**Request for Variances &  
Alternative Analysis In Support of the Variance Request  
74, 80 Maynard Road (Map G08, Lot 0025 & 0500), Sudbury MA**

BUFFER MITIGATION PLAN  
- BONNIE BROOK ESTATES -  
DEFINITIVE PLAN OF LAND  
MAYNARD ROAD  
SUDBURY, MA

Re: 74-80 Maynard Road, DEP file # 301-1341

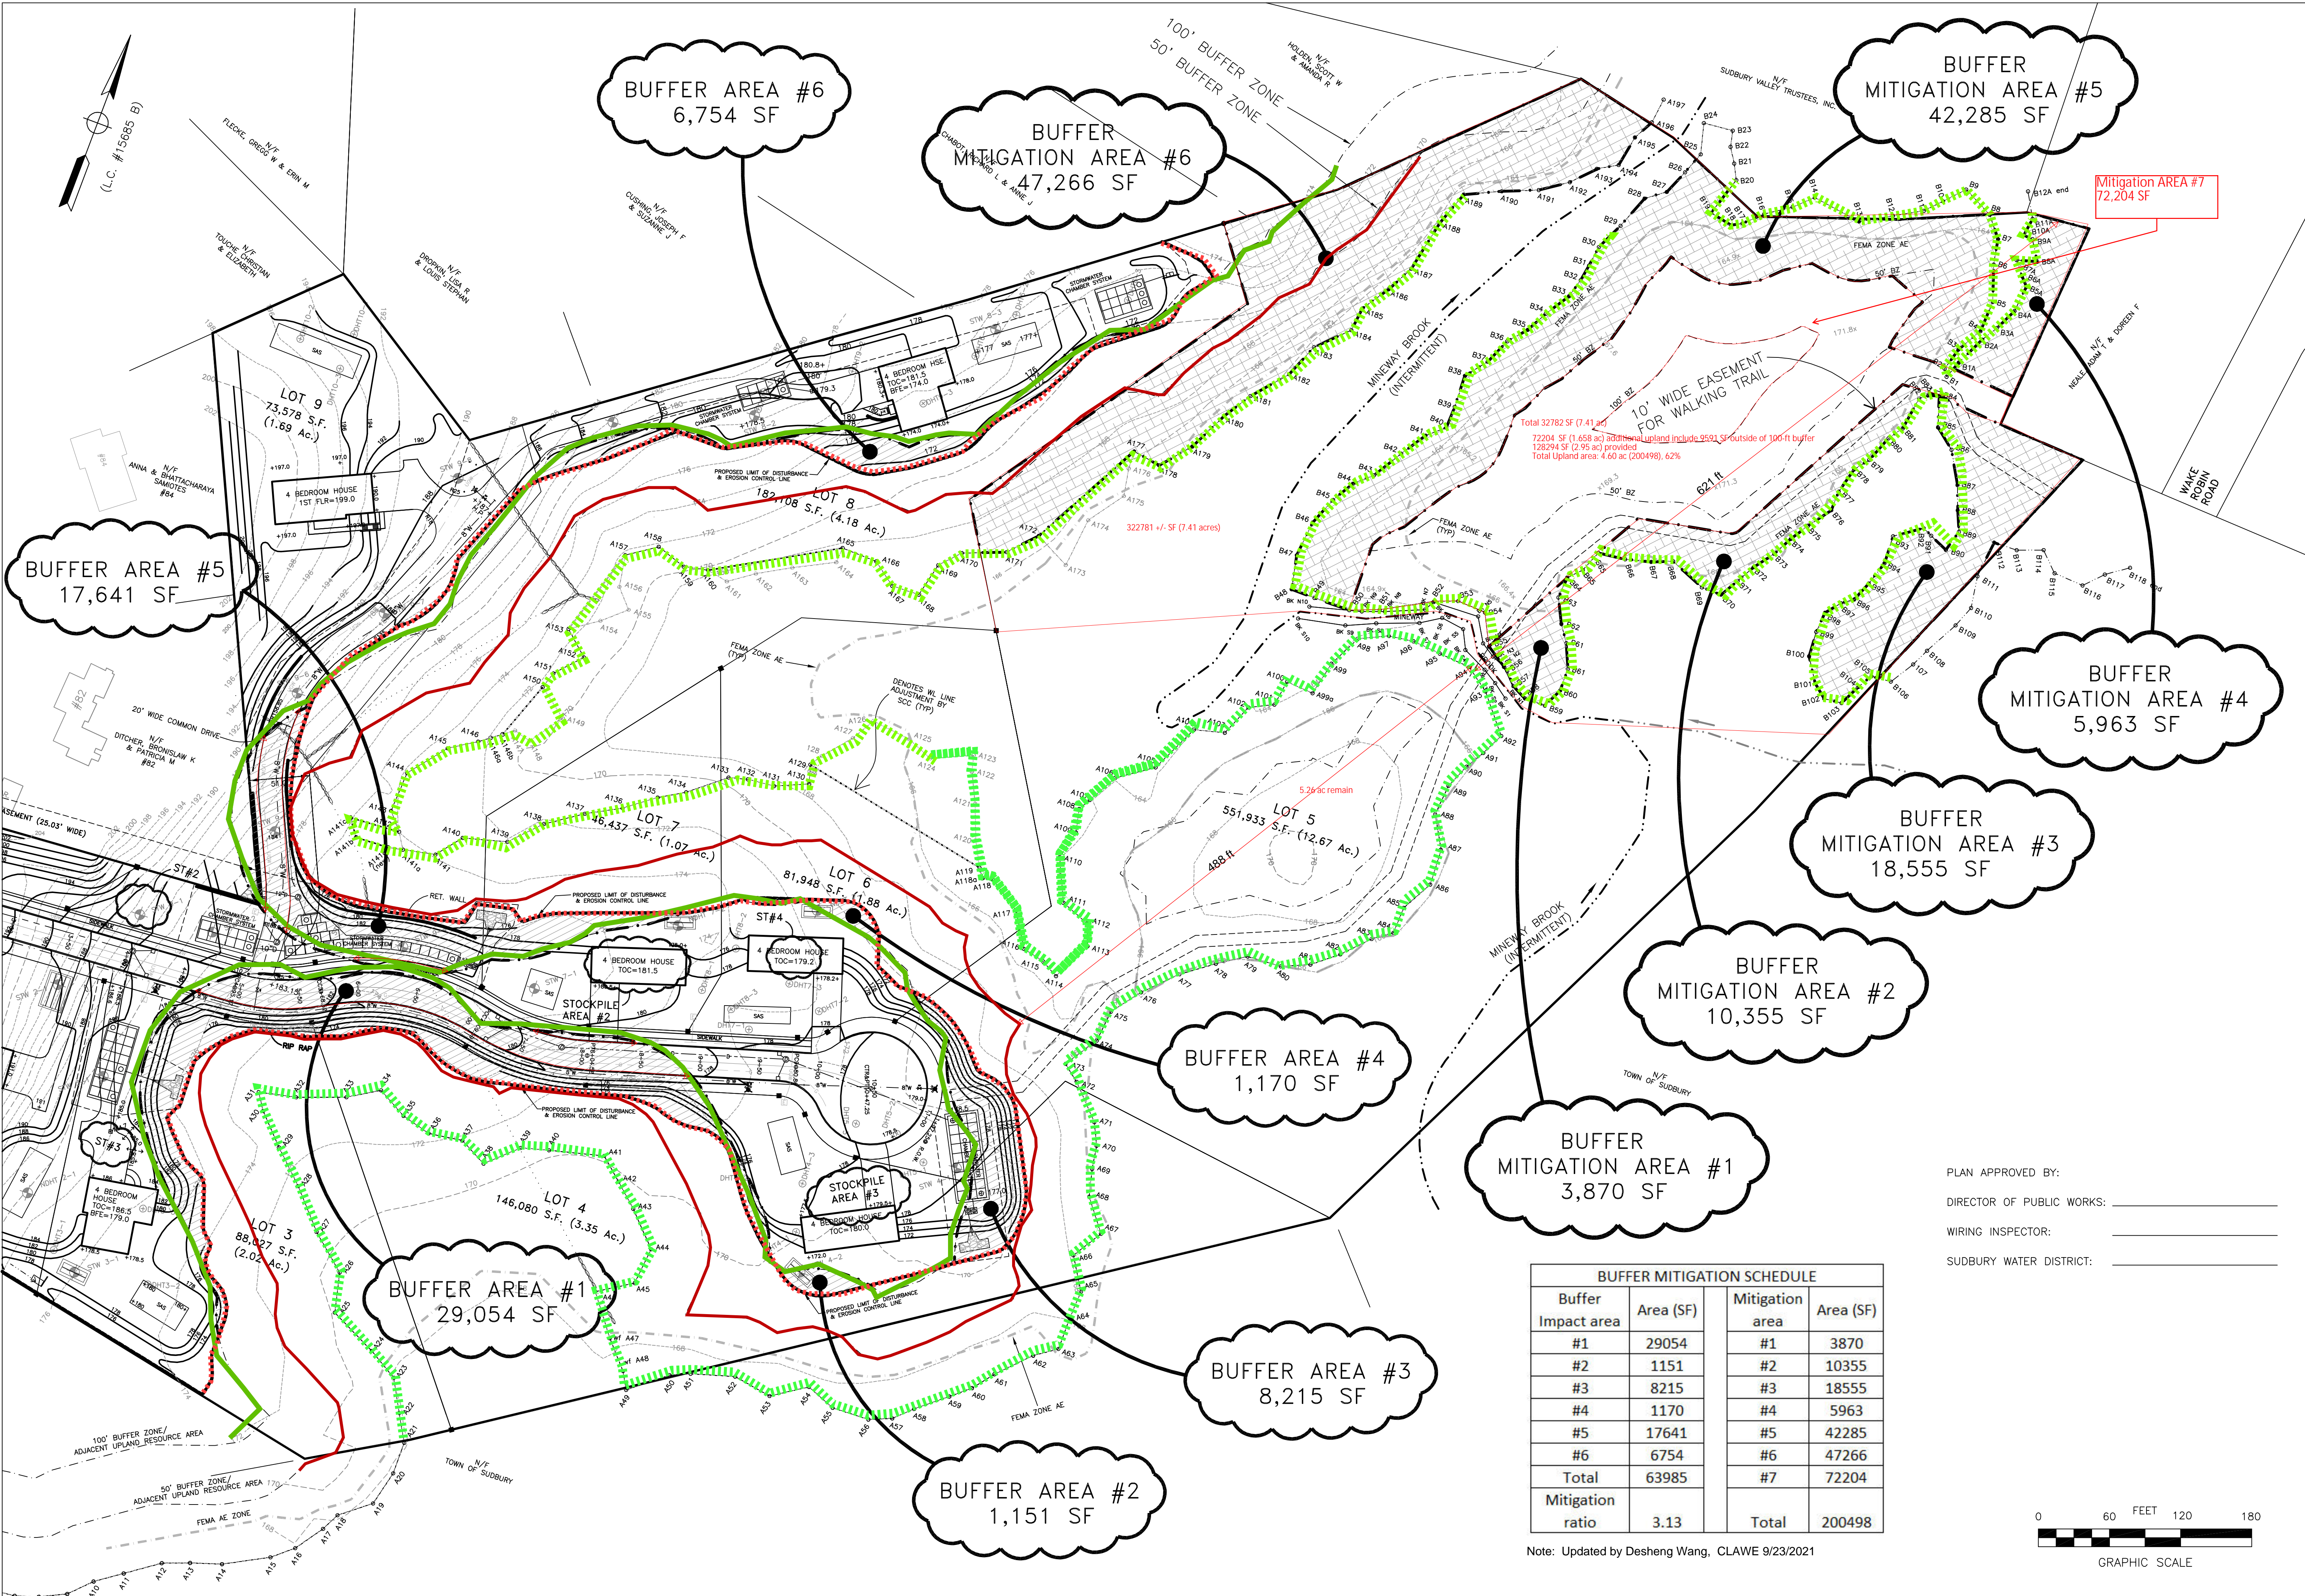
After we have site visit and extensive discussions with Ms. Capone, the applicant is proposing a more Comprehensive mitigation to include the entire large peninsula of 3.62 acres of upland and a total 7.41 acres of land creating a more than 620-ft wide connection corridor between SVT and the Town Conservation Land. The rest of Lot 5 will not be buildable and make the total area over 12 acres in open space with a corridor over 1100 ft wide for wildlife. The total upland area to be preserved will exceed 3:1 ratio for the proposed access roadway and some minor grading in some houses' backyard to avoid significant vertical retaining wall barrier. See the updated Alternative analysis report and Mitigation plan for details.

After field inspection and discussions with Conservation commission, the applicant is proposed the fourth alternative to increase mitigation area significantly from 2.95 acres upland area mostly in 0-50 ft buffer zone to 4.6 acres (3.13 to 1 mitigation ratio) including area of 1.66 acres of area outside of 50 ft buffer, of which 9591 sq. ft (0.22 acres) area is located outside of 100-ft adjacent upland resource area, which would be buildable area under the current bylaw. This will permanently protect a total of 7.41 acres of land which will provide a 600 ft wide connection corridor between the SVT and Town of Sudbury Conservation land. 22.41% of total upland and 24.48% of total land area will be permanently protected. The subdivision will also provide an affordable building lot to the Town. The applicant would lose a buildable lot by providing this new mitigation and hope the Planning Board can consider waiving the requirement on the remaining 8 lots for another affordable lot. See Tables 3 and 4 for details.
